Service BULLETIN

APPLICABLE TO 64348, 64349 & 64049
NOZZLES AS OUTLINED BELOW

SB3480801A
Nov. 1, 1998

REVISION TO AUGUST 1, 1998 BULLETIN! NEW TWO-PIECE HANDLE BREAKAGE REPORTED

FIGURE 1

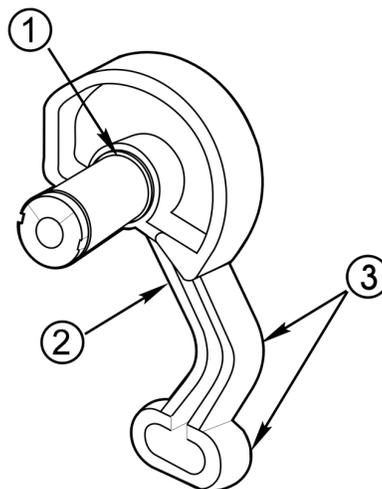
It has been reported that several of the newer 220878-1 handles have been broken on nozzles installed on hose reel applications. Reports of leakage from the handle shaft area were initial signs of breakage. Reports of the single screw coming loose were also signs of the breakage. The handle is an integral part of the nozzle interlock system. The breakage, result of mishandling (dropping), has occurred at a machined radius area “1”, as shown in Figure 1 on the next page. If not detected, further use can cause

the handle to loosen and overcome the interlock system. The result can then be a possible spill since it can then be possible for the operator to take the nozzle off of the aircraft with the nozzle poppet in the open position. The breakage has been the result of impact on the handle in the areas marked with a “3”, Figure 1. The handle first bends until it contacts the carrying handle or sometimes the bolt head attachment of it. The bolt head impact results in an impression in the handle and produces a stress riser in the area marked “2” which may result in the handle breaking at that point. This is a maintenance problem but not a safety issue. Further impacts in the areas marked “2” and “3” can result in the fracture at “1” which is the object of this bulletin. All operators should be provided the following information (instructions) to prevent spills and possible bodily injury from spilled fuel:

1. **No nozzles, to our knowledge, have had a handle breakage problem where they are installed on a deck type application; hence dropping is a major contributor to the problem. Even though it has been done in the past, another caution not to drop the nozzle should be extended to the operators.**
2. **If fuel leakage, no matter how slight, appears from the area of the operating handle do not use the nozzle. Take it out of service immediately. Inspect the handle for evidence of a crack at “1”. It may start out as a very minute crack and may be difficult to see with the eye. Replace the handle if not certain.**

If the handle or attaching screw appear to be loose, DO NOT ATTEMPT TO TIGHTEN THE SCREW, you will only cause the insert in the crank to be damaged. Remove the nozzle from service immediately.

The design of the handle does not allow for any other type of manufacturing (within cost limits) than die-casting. The material of all three types of handles, although much stronger than an aluminum die casting, has minimum ductile properties (properties that allow bending rather than breakage). The solution to the problem therefore is to change to a more ductile material that will allow for severe bending but no breakage within the physical limits of the geometry of the handle installation. This will prevent the potential spills now apparently possible. When the handle is bend beyond use (and does not break) then it will have to be replaced. Preventing the operator from dropping the nozzle will minimize the maintenance costs greatly. If a hose end regulator is also used then the installation of a drag ring will also prevent the handle from being damaged. Ask your Carter distributor for more information on this possibility. The drag ring, as it is apply named, is a sacrificial part that prevents wear from dragging the nozzle while rewinding the hose reel.

The new more ductile material will be available shortly. It will easily be identified since it will be black in color in lieu of the normal gray aluminum color of the existing one. The part number will remain the same and all future production nozzles will be fitted with the new handle. Return any broken handles (in the area marked “1” only) to your Carter distributor for a free replacement kit to upgrade the nozzle. Replacement kits, KD64349-12, will be used to replace the broken handles. The kit will contain the parts needed to replace the handle and attaching parts only. All future orders for 220878-1 Handles will be filled with the newer material.

1. Torque the screw in the outer portion of the handle to 115 ± 5 inch pounds.
2. This is only a temporary solution designed to make the nozzle safe. Notify your Carter Distributor immediately of the number of gray two-piece handles you have in use. (Carter Distributors – Order the number needed of replacement Kit KD64348-12 at no charge immediately. If your records are such that you can identify the nozzles shipped from your store by the serial number you can order the correct number immediately without asking your customer for the number. This will only cover new nozzles shipped from the factory with the new handles. You will still have to ask about any upgraded nozzles that you may have replaced with the KD64348-12 previously.)

1. Torque the screw in the outer portion of the handle to 125 ± 5 inch pounds.
2. When installing the new handles replacing the above gray handles, torque to 125 ± 5 inch pounds, loosen the screw and retorque to 125 ± 5 inch pounds.
